City of Huron  
Agenda for the Planning Commission/DRB  
Wednesday, December 17, 2025 5:00pm.

**TO:** Chairman Boyle and Members of the Planning Commission and Design Review Board  
**FROM:** Christine Gibboney Planning & Zoning Manager  
**RE:** Woodlands Elementary School- Accessory Structure- Covered Walkway  
**DATE:** December 17, 2025

**TO:** Chairman Boyle and Members of the Planning Commission and Design Review Board  
**FROM:** Christine Gibboney, Planning & Zoning Manager  
**RE:** Port Huron Plaza- 525 Cleveland Road W- Unit 511-A- Commercial Signage  
**DATE:** November 19, 2025

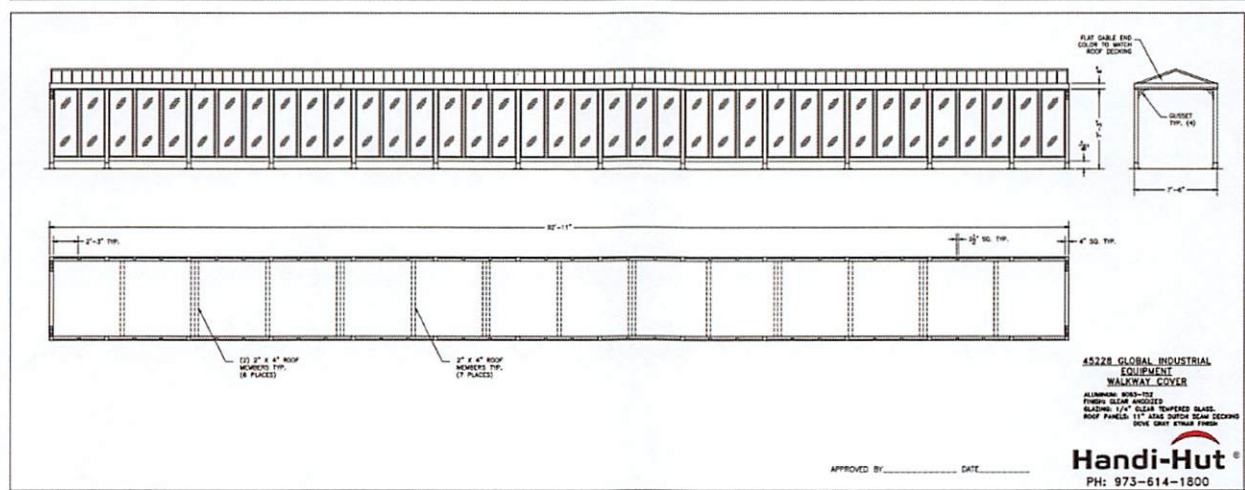
The proposed detached covered walkway would be considered an accessory structure and would be positioned over the existing concrete sidewalk leading up to the west side entrance to the school. This is the location of the drop-off/pick-up of students. The structure is a prefabricated glass and aluminum outdoor shelter from Handi-Hut, which will be 92' in length and 7'-3" in height, providing shelter to the children to get from Lake Erie Parkway into the west side entrance. To view

The school is located within a R-1 Single-Family Residential District, the only setback regulations are that the structures are not to be located less than 40' from any other lot in an R District. As proposed, the structure will more than meet this criteria. The height will also be compliant with that of an accessory structure.

The setbacks of the structure to the property lines are as follows:

486' to the North (abutting R-1)

70' to the West (abutting B-3)

465' to the South (abutting highway)

Staff recommends the approval of the site and design plans as presented.
